SUBJECT: Resource Conservation and Recovery Act Facility Investigation/Remedial Investigation Report with Baseline Risk Assessment and Corrective Measures Study/Feasibility Study for the Early Construction and Operational Disposal Site N-1 (NBN), Central Shops Scrap Lumber Pile (631-2G), and Building 690-N, Process Heat Exchanger Repair Facility (aka Ford Building) Operable Unit (U) (SRNS-RP-2021-00548, April 2022, Revision 1 Redline) and Savannah River Site's Responses to the Regulatory Comments on the Revision 0 Document, SEMS Number: 93

1. Resource Conservation and Recovery Act Facility Investigation/Remedial Investigation Report with Baseline Risk Assessment and Corrective Measures Study/Feasibility Study for the Early Construction and Operational Disposal Site N-1 (NBN), Central Shops Scrap Lumber Pile (631-2G), and Building 690-N, Process Heat Exchanger Repair Facility (aka Ford Building) Operable Unit (U) (SRNS-RP-2021-00548, April 2022, Revision 1 Redline) SEMS Number: 93

2. SRS Responses to South Carolina Department of Health and Environmental Control Comments on the Resource Conservation and Recovery Act Facility Investigation/Remedial Investigation Report with Baseline

Revised Figure 1-6. Ford Building 2020-2021 (Specific Comment #2)

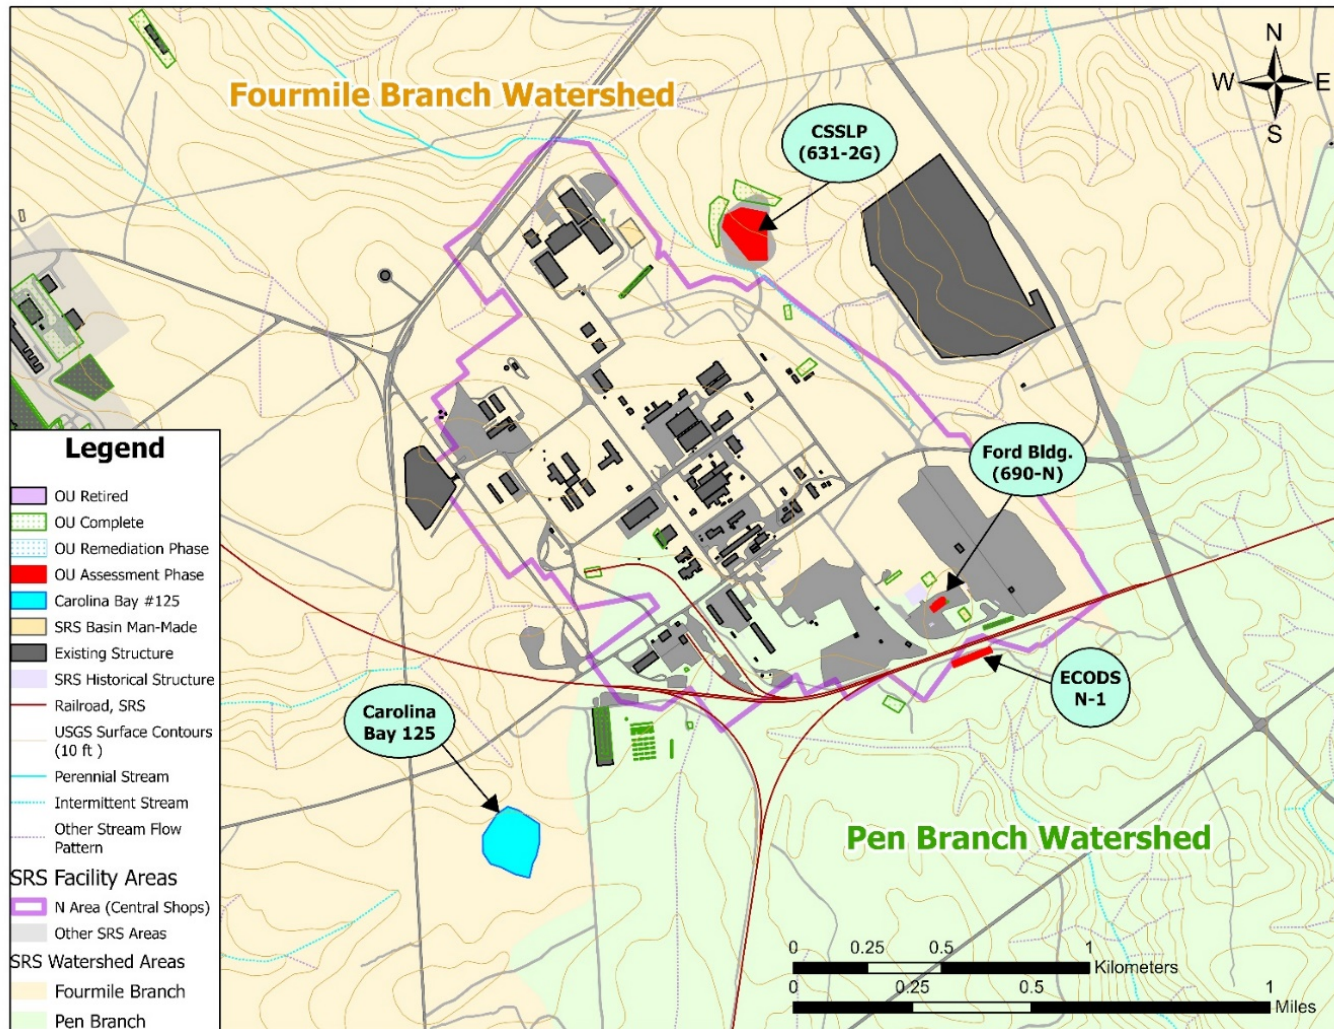
- 2. Figure 1-6, Ford Building 2020-2021, Page 1-16 of 1-18:** The Ford Building concrete cover/remnant slab is not identified on the figure. Additionally, a small green circle located just to the east of the assumed building slab has not been identified. *Please revise the figure*
-

to clearly identify the Ford Building concrete cover/remnant slab and the small green circle on the figure.

The Ford Building (690-N) concrete cover and small green circle will be identified in Figure 1-6. The small green circle is the location of a AROPOL spill (15 gal) in 1985 and closed by the Site Evaluation program in 1998. The revised Figure 1-6 is attached.

Revised Figure 2-2. Central Shops (N Area) Surface Water Run-Off (Specific Comment #3)

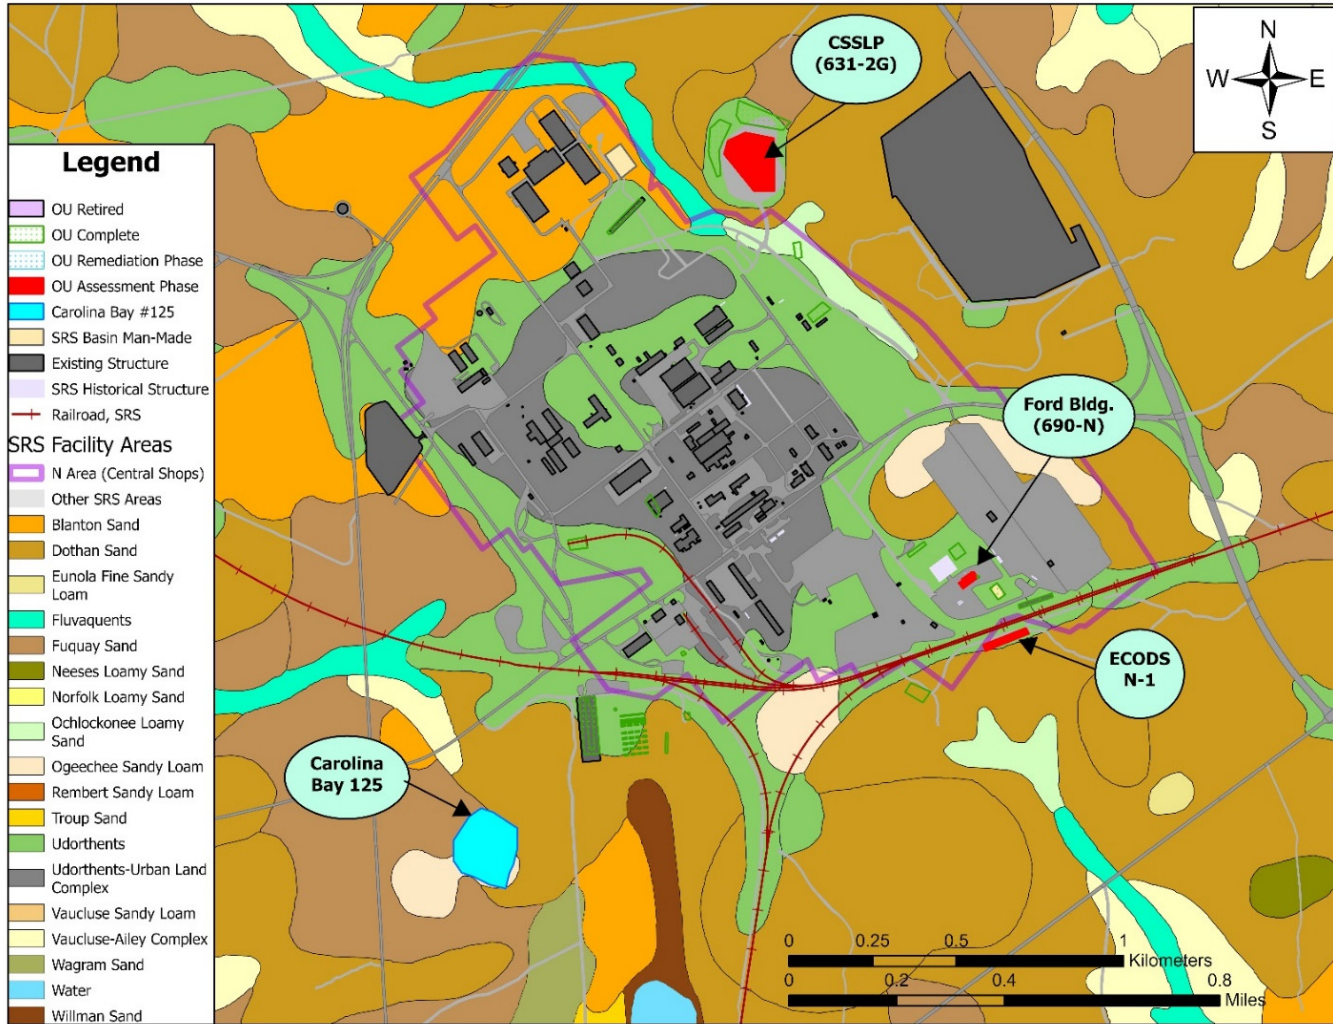
3. **Section 2.1.2, Surface Features, Page 2-3 of 2-24:** A topographic map is not presented to support the assertions in the text that the Ford Building subunit is located on a topographic ridge between the Pen Branch and Fourmile Branch watersheds. For example, the text states the Ford Building is in the southeastern portion of the Central Shops Area on a topographic ridge between Pen Branch and Fourmile Branch with the surface elevation and the land gently sloping radially downgradient from the Ford Building. The text references Figure 2-2 (Central Shops [N Area] Surface Water Run-Off, Page 2-12 of 2-24)]; however, no topographic contours of the ground surface elevation are depicted. *Please revise the Report to include a figure with topographic contours illustrating the groundwater surface elevation and topographic ridge between Pen Branch and Fourmile Branch.*

Figure 1-1 shows the watershed boundaries and the water table contours. The land surface contours will be added to Figure 2-2. The revised Figure 2-2 is attached.

Revised Figure 2-4. Soil Series in the Central Shops (N Area) (Specific Comment #8)

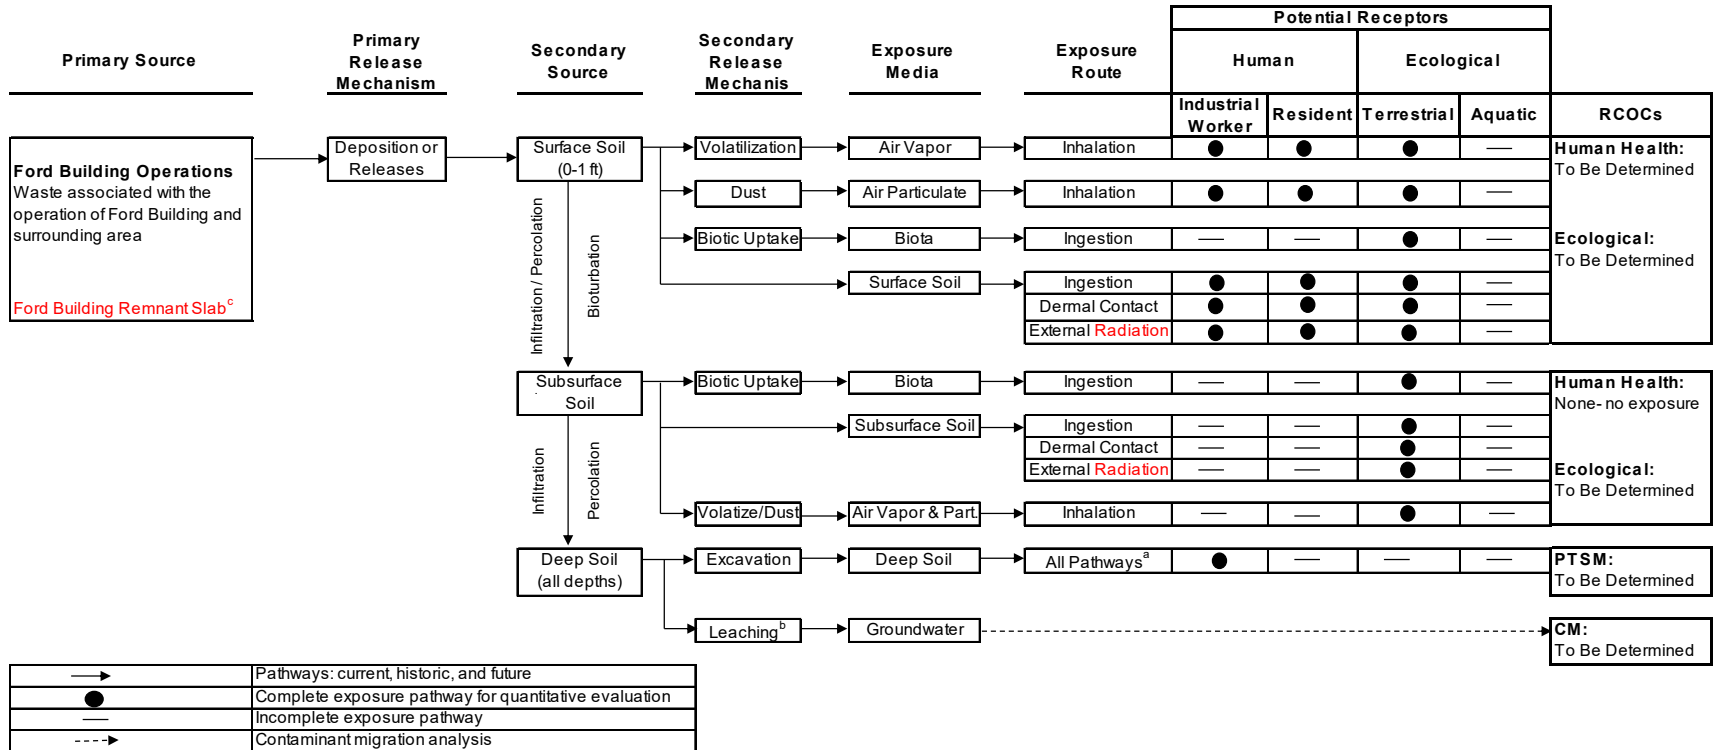
8. **Figure 2-4, Soil Series in the Central Shops (N Area), Page 2-15 of 2-24:** The soil types depicted in this figure are not easily identifiable. For example, the color coding used to define the different soil types depicted in the figure legend are too similar. *Please revise the figure to clearly depict soil types using colors that can be easily distinguished from one another.*

Figure 2-4 will be revised with a wider range of colors for the different soil types. The revised Figure 2-4 is attached.

Revised Figure 2-2. Central Shops (N Area) Surface Water Run-Off (Specific Comment #4)

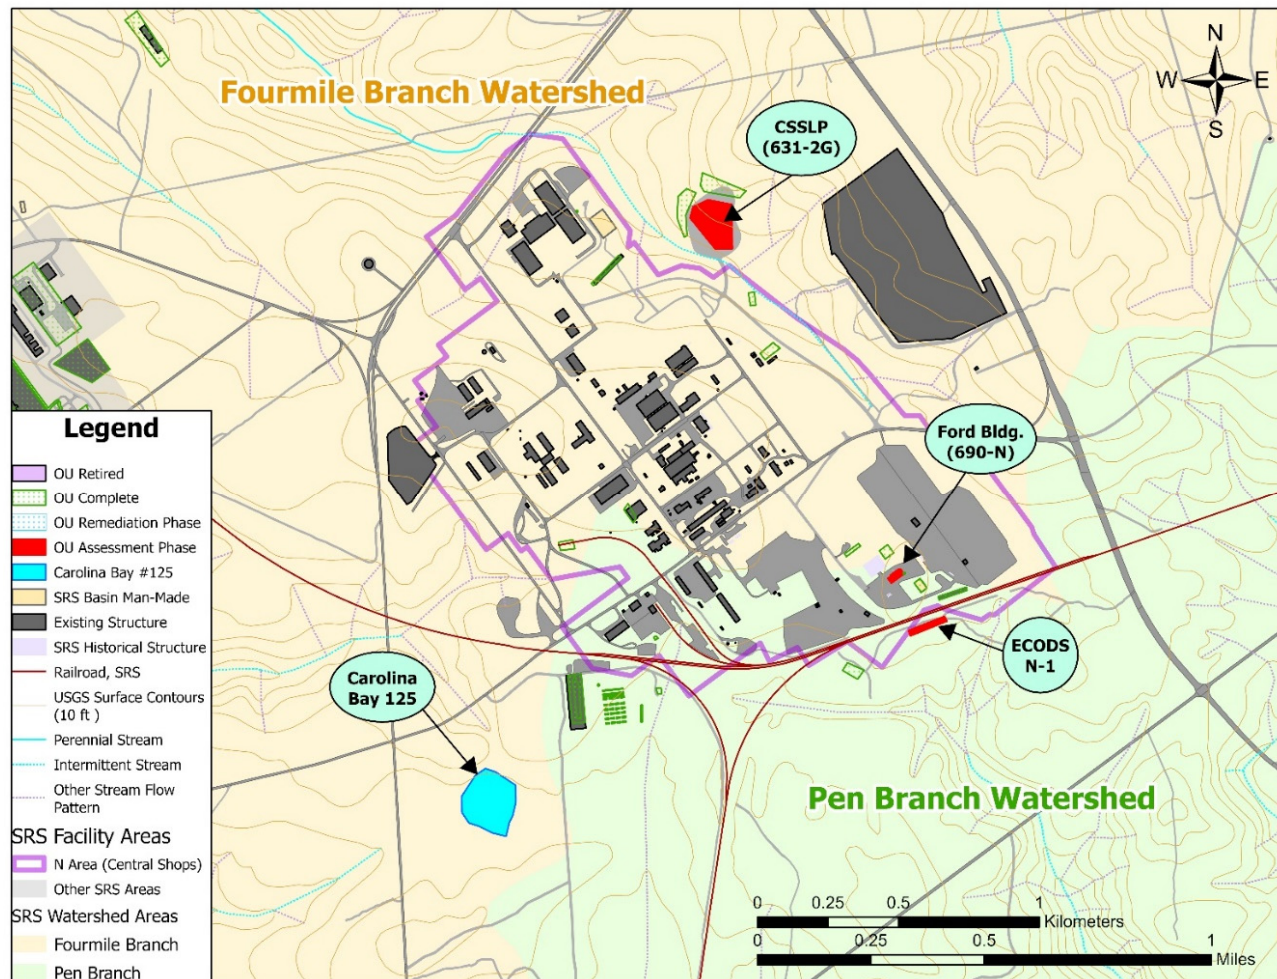
4. Figure 3-2, Central Shops Scrap Lumber Pile (631-2G) Sample Locations, page 3-36. This figure shows an insert of Carolina Bay #125, yet the location of the bay in relation to the CSSLP is unclear. Please depict the location of Carolina Bay #125 on this figure or a separate one.

Figure 2-2 has been revised to show the Carolina Bay #125 in relation to the CSSLP. The figure is included at the end of this document. No change to Figure 3-2 is proposed. Both Figure 2-2 and Figure 3-2 will be referenced in Section 3.2.2 as follows:
